IEEE P802.3az

Asymmetric and symmetric modes

Symmetric and asymmetric operation

1000BASE-T symmetric operation

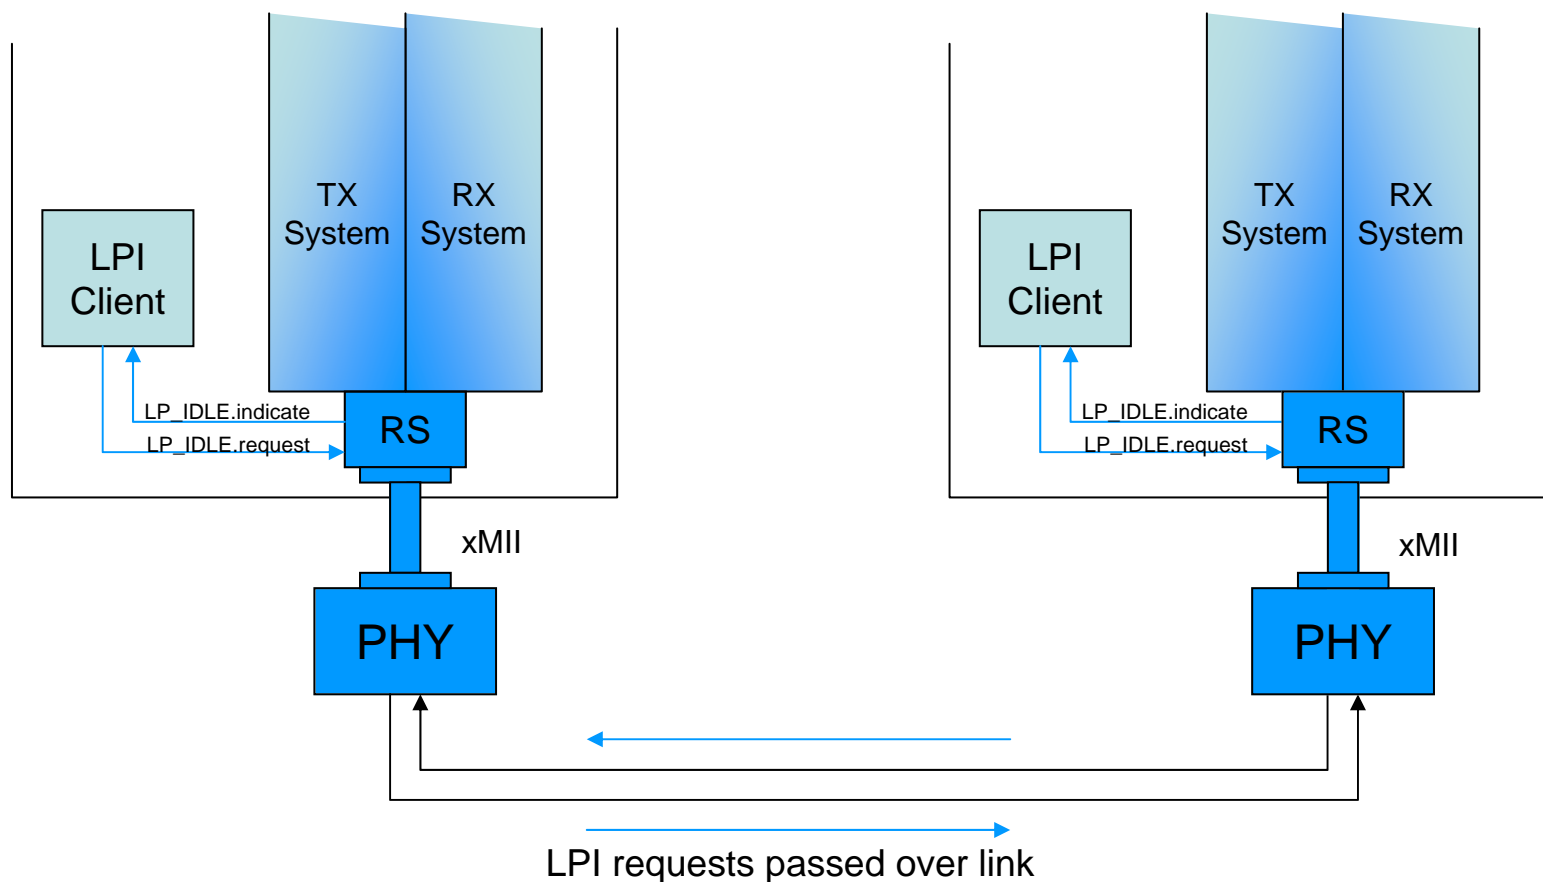
LPI request passed over link so system energy savings as Asymmetric
